# Product Change Notification (PCN)

PCN Number	505099	Date Issued	December 19, 2017
Reason for Change	Supplier Change		
Change Type Description	This letter is to inform you that Molex is adding a new supplier or the supplier is making a change affecting the part(s) identified in this notice. There will be no negative impact to product performance as a result of this change.		
Reason for Short Notice	New Capacity		
Assessment of Change	Dimension analysis		
Internal Molex Qualification Date	January 15, 2018		
Sample Availability Date (Changed Part)	January 15, 2018		
Planned Implementation Date	March 19, 2018		
Method of Identifying Change	Cavity identification

**Image of component of finished goods**

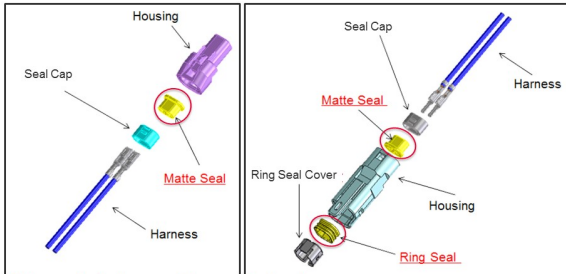
The red circles are the parts to change.

- Silicon rubber supplier change to improve delivery time & quality. To respond to increased demand.
- Product Impact
  - no impact to fit, form or function
- Part Number Impact
  - See attached impacted parts list.
- Qualification Reports and samples available upon request after the date shown above.
